GFA AD 445

GFA AIRWORTHINESS DIRECTIVE

LS 3, LS 3a, LS 3-17.

Air brake drive mechanism inspection and modification.

Drawing of root rib and air brake drive, indicating regions for adjustment of play:

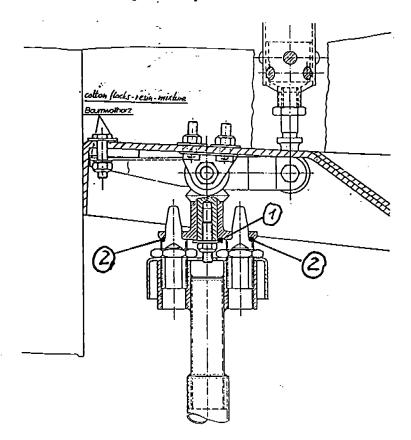
- : 1) Check play in bevel gear drive at root ribs:
 : The bevel gear drive plate must be axially free from play, but should be unbraced. Compensation of play by shims 16*12 mm (When this play is excessive, the plate may skip over one or more teeth, resulting in air brake being either not completely retractable or extendable).
 See also drawing on page 2.
 - After rigging the plane check spanwise play of fuselage air brake drive between bevel gears with air brakes not locked. Also, this value must be free from play, but unbraced.

Compensation of play by shims 14*10 mm. (When this play is excessive, the root rib is being deformed during locking, resulting in possible failure of the bevel gear plate retaining bolt and also air brake being either not completely retractable or extendable).

3) Modification of the air brake bevel gear unit to version "a" (Drawing 1BF-4a), identifiable by locking nut M8, width over flats 13 mm at the gear drive plate, instead of locking nut M6, width over flats 10 mm.
